Central Zoo Authority

F. No. 19-123/93-CZA(267)(Vol. I)(M) 3640

DATE: 26.09.2013

Sub:- Designs for the construction of Rescue Centre and Leopard Proof Fencing at Malsi Deer Park, Dehradun.

P. JAIN & Co. ARCHITECTS, CIVIL ENGINEERS, INTERIOR DESIGNERS AND VALUERS		LEOPARD RESCUE CENTRE		NUMBER	SCALE-1:150
CODE	PROJECT	FILE	DATE	PAGE	
XXX	DEHRADUN MINI ZOO		30/08/2013		
151/3 Rajpur Road Dehradun 248001 Tel: 0135 8452264 Telefax: 0135 2735867 E-mail: p.jitumtunnrediffmail.com

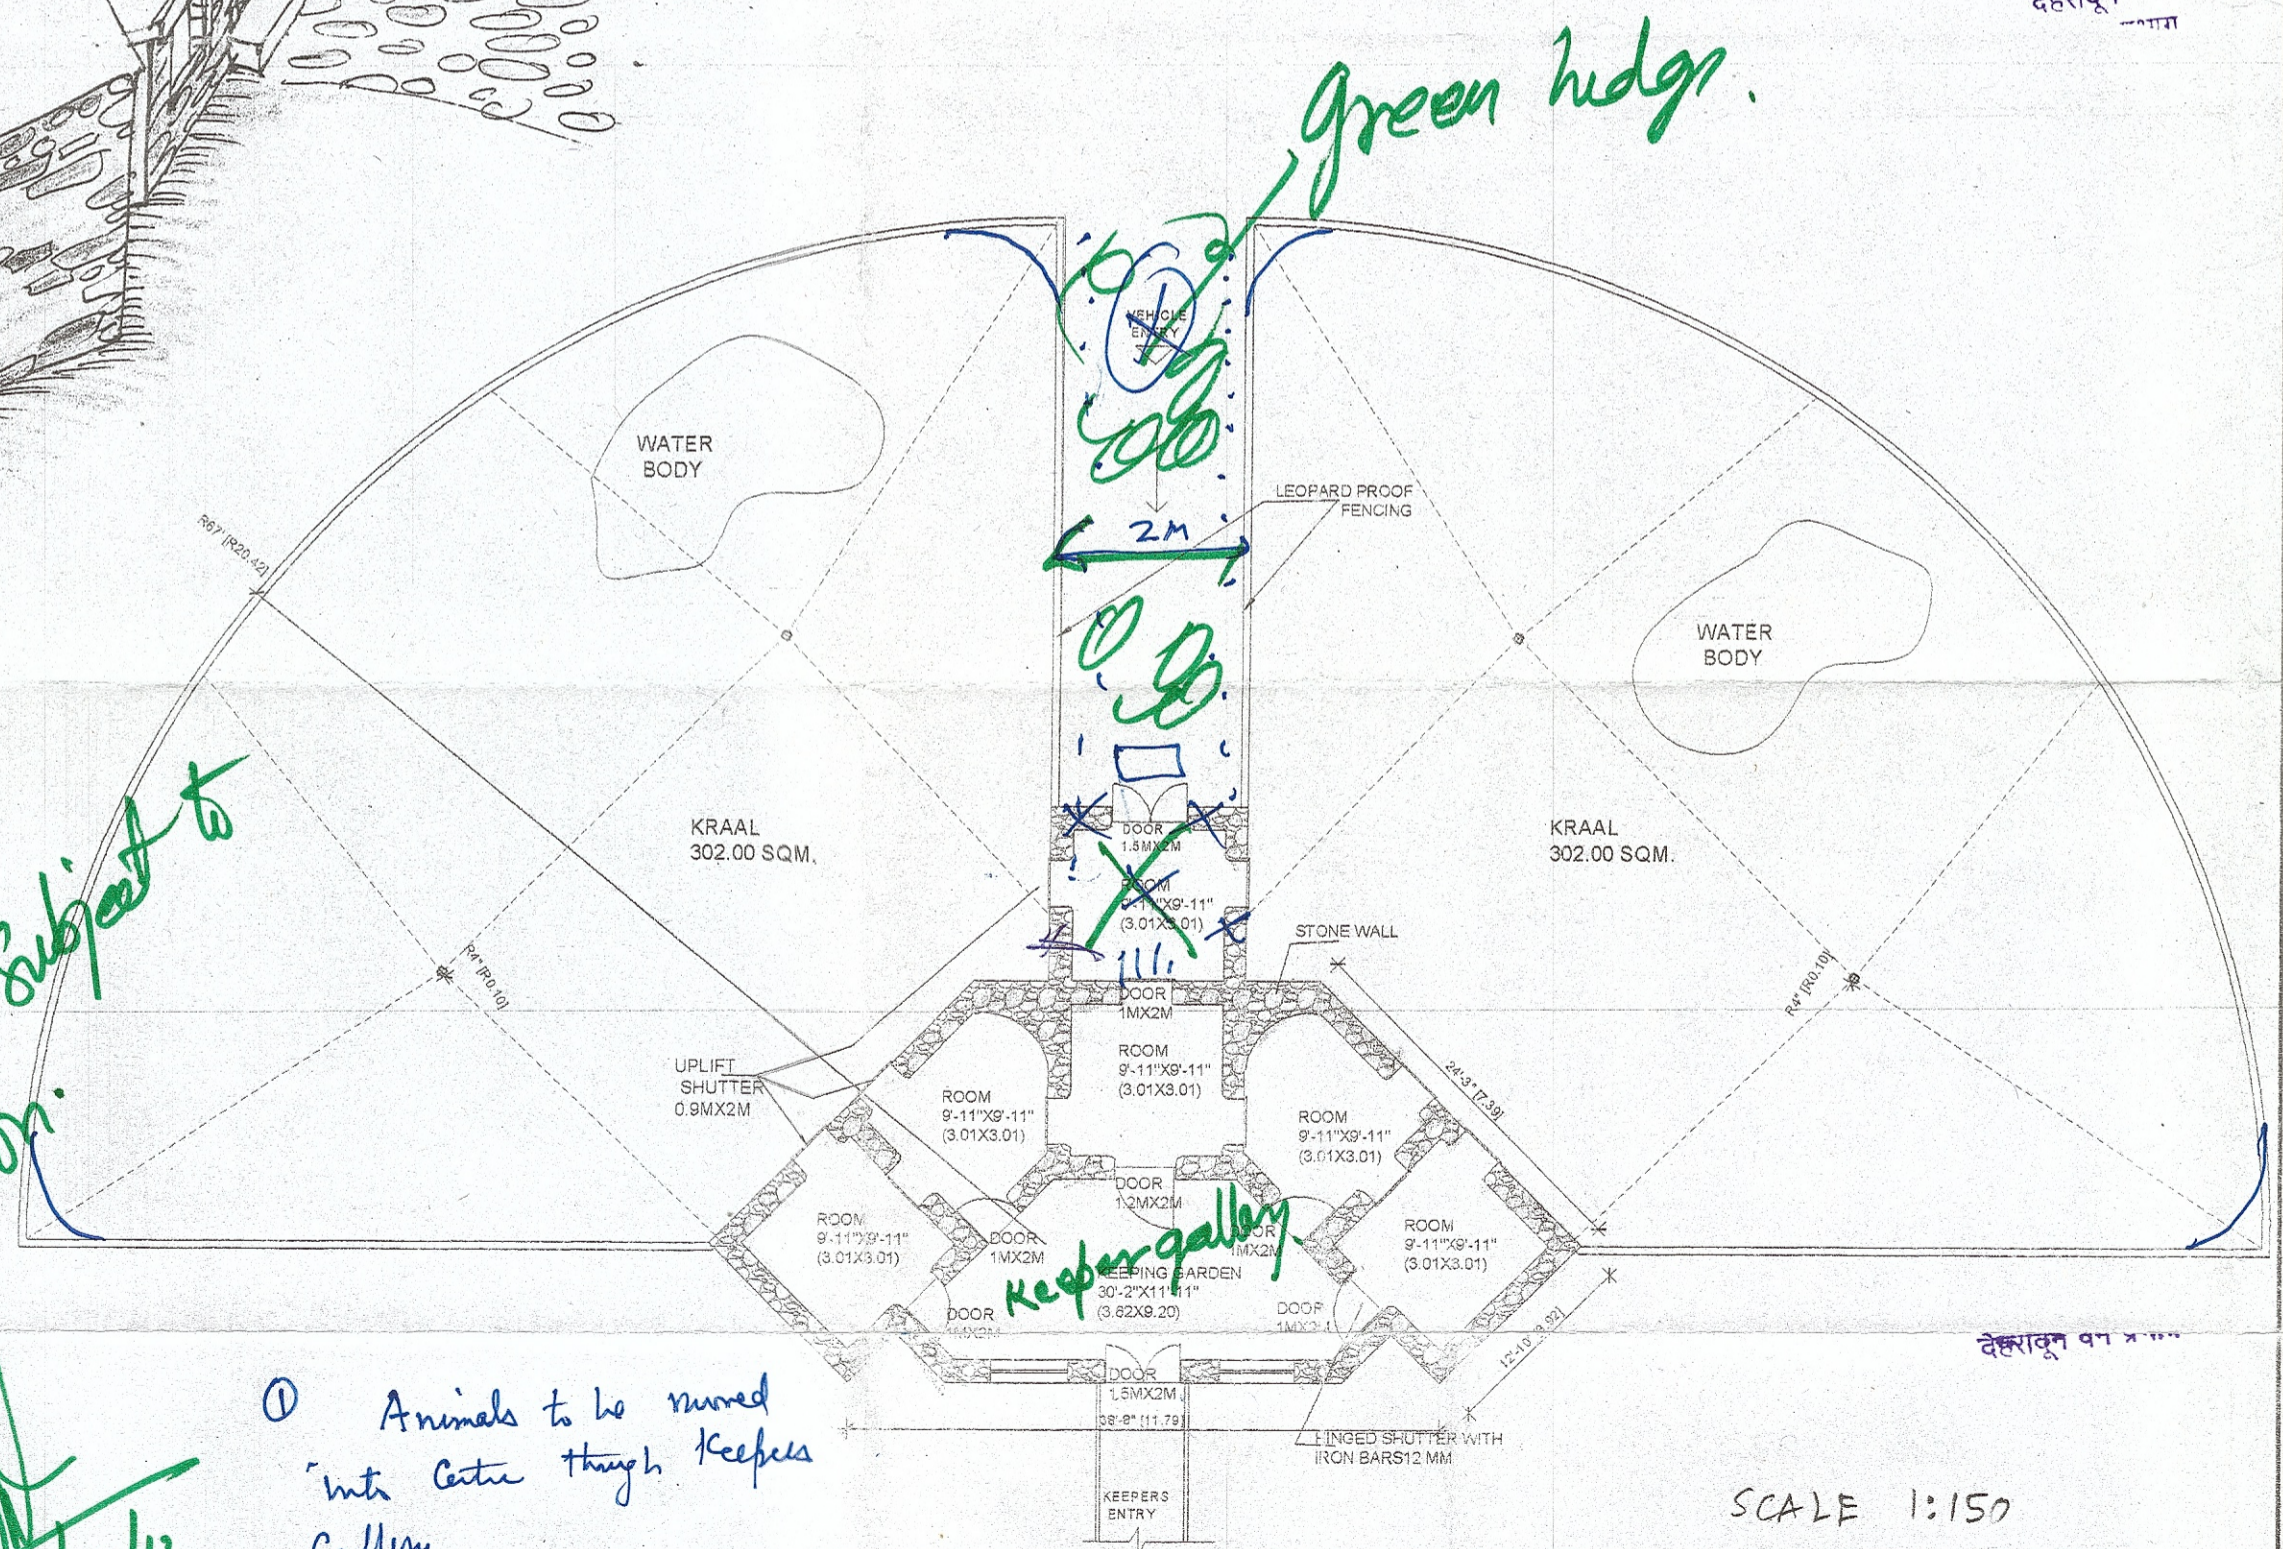
1. Animals should be moved into the paddock area of the centre through keepers gallery.
2. The design should avoid acute angle instead curvilinear structure should be adopted.

Approved. Subject to change as per minor.
[Signature]
 05/09/13
 (As per Expert Group to Bengali meeting)

- ① Animals to be moved into Centre through Keepers Gallery
- ② Round off of acute angles.
